# Access Compliance Report

## Public Rights-of-Way

### (Curb Ramps)

Intersection ID: 11200	Main Street: MILTON_RD	Cross Street: VILLAGE_GREEN_DR	Location: SE
ADA ID: FA745010D2F0	Ramp Type: Perp	Initial Pass/Fail: Fail	Overall Compliance: No
Codes/Mitigation Info/Possible Solution			Severity Score: 10
			Field Measurements/Component Compliance

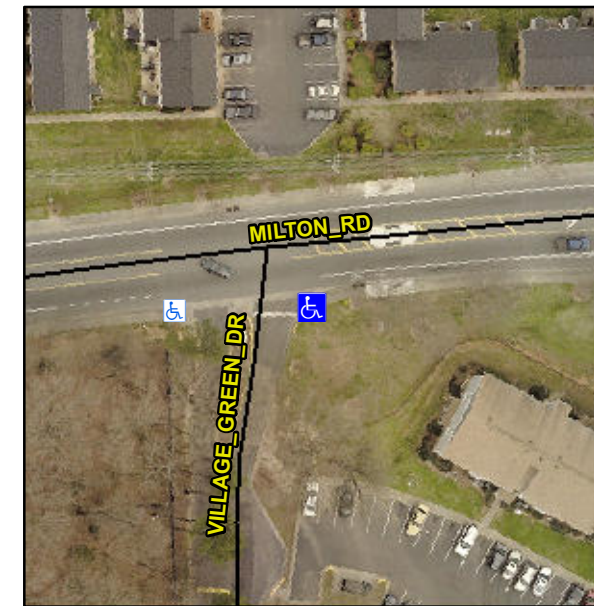
**Not Found, R304.5.1, R304.5.3**

Compliance	Description	Data	Compliance	Description	Data
N/A	Ramp Length (in)	59.5	Yes	Ramp Slope (%)	7.3
No	Ramp Width (in)	41.5	No	Ramp XSlope (%)	4.0
N/A	Flare Type LT	N/A	N/A	Flare Type RT	N/A
N/A	Flare Slope LT (%)	N/A	N/A	Flare Slope RT (%)	N/A
N/A	Flare Traversable LT?	N/A	N/A	Flare Traversable RT?	N/A
N/A	Landing Length (in)	N/A	N/A	DWS Provided?	N/A
N/A	Landing Width (in)	N/A	N/A	DWS Contrast?	N/A
N/A	Landing Slope (%)	N/A	N/A	DWS Length (in)	N/A
N/A	Landing X Slope (%)	N/A	N/A	DWS Full Width?	N/A
N/A	Landing Curb? (Y/N)	N/A	N/A	DWS Offset (in)	N/A
N/A	Shared Landing?	N/A			
N/A	Gutter Ponding?	N/A	N/A	Gutter Slope (%)	N/A
N/A	Gutter Lip Ht (in)	N/A	N/A	Gutter X Slope (%)	N/A
N/A	Painted X Walk1?	No	N/A	Painted X Walk2?	N/A
	X Walk 1 Direction	To W		X Walk 2 Direction	N/A
N/A	X Walk 1 Width (in)	N/A	N/A	X Walk 2 Width (in)	N/A
	X Walk 1 Slope (%)	1.2		X Walk 2 Slope (%)	N/A
	X Walk 1 X Slope (%)	8.1		X Walk 2 X Slope (%)	N/A

**Remove & Replace Entire Ramp.**
